MEMO

Case Number: AME2018 0004: Alternative Development Overlay District

RE: Proposed changes to Alternative Development Overlay District (ADOD) (emphasizing sight distance) and applicability of American Association of State Highway and Transportation Officials (AASHTO) standards

ADOD Edits, T49 March 31. 2022

§1430 Fig. 1

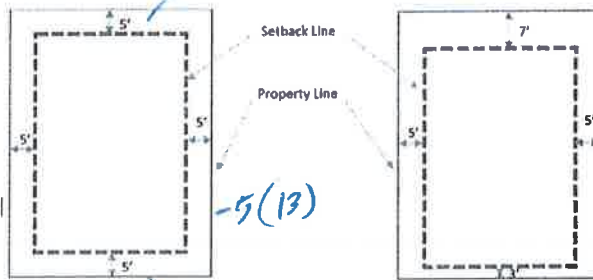
*(exceptions for out-sulation?)
check consistency.*

(where defined?)

*Relative to min 50'
D-5
40'-D-18*

FIGURE XX?

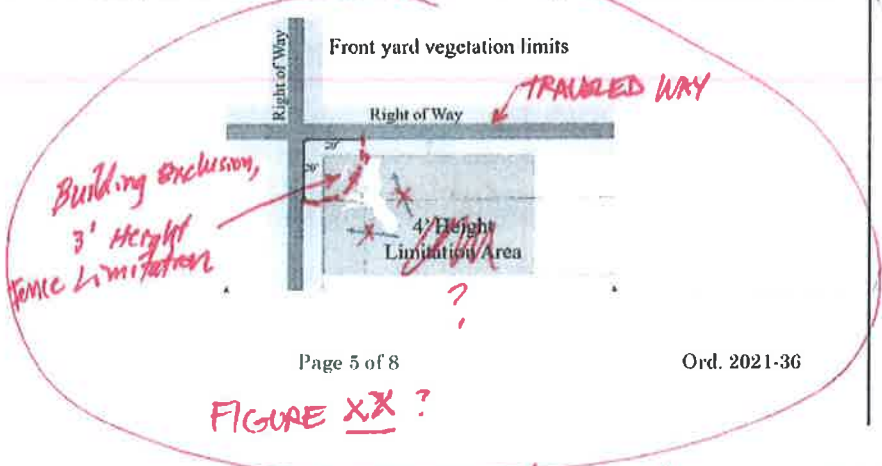
(with 49.50.1450)

Commented [RP12]: Revise figure:

- 1. Change figure to say Travel way instead of ROW
- 2. Add 3 foot height limitation in the figure for the corner

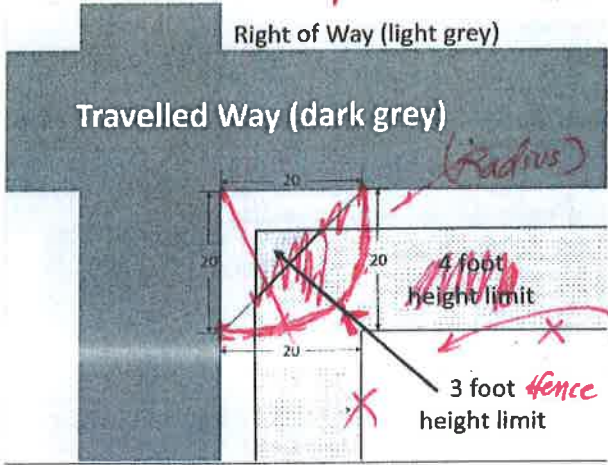
A) Building expansions are not permitted through ADD within a radius of 20' of the street traveled way at a street intersection.

in height within a radius of 20' of the street traveled way at a street intersection.

← C. Sight-obscuring trees are not allowed within a radius of 20' (ditto above)

(only one exhibit needed,
this scale is better.)
?
